Docket Number:	15-AFC-02
Project Title:	Mission Rock Energy Center
TN #:	222795
Document Title:	San Buenaventura Conservancy Cultural Impact Comments
Description:	N/A
Filer:	System
Organization:	San Buenaventura Conservancy
Submitter Role:	Public
Submission Date:	3/1/2018 12:04:30 AM
Docketed Date:	3/1/2018

San Buenaventura Conservancy Cultural Impact Comments

Subject: Preliminary Comments on PSA, Mission Rock Energy Center

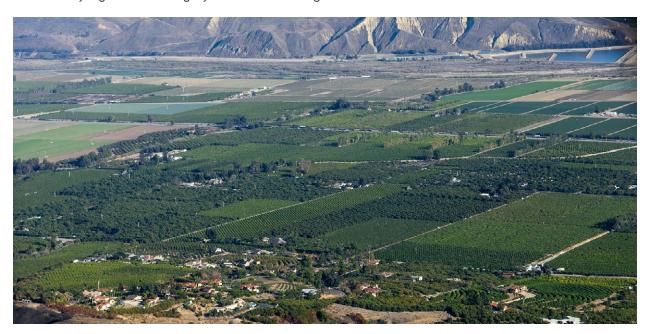
Mitigations of the proposed More-Edwards Adobe (above) and the Sharp-Thille House, are laudable as preservation projects but have only a tenuous nexus to the adverse impacts caused by the bisection of the Heritage Valley by transmission lines. Off-site restoration efforts to the More-Edwards Adobe and the Sharp-Thille gardens produce little public benefit because they are both not publicly accessible.
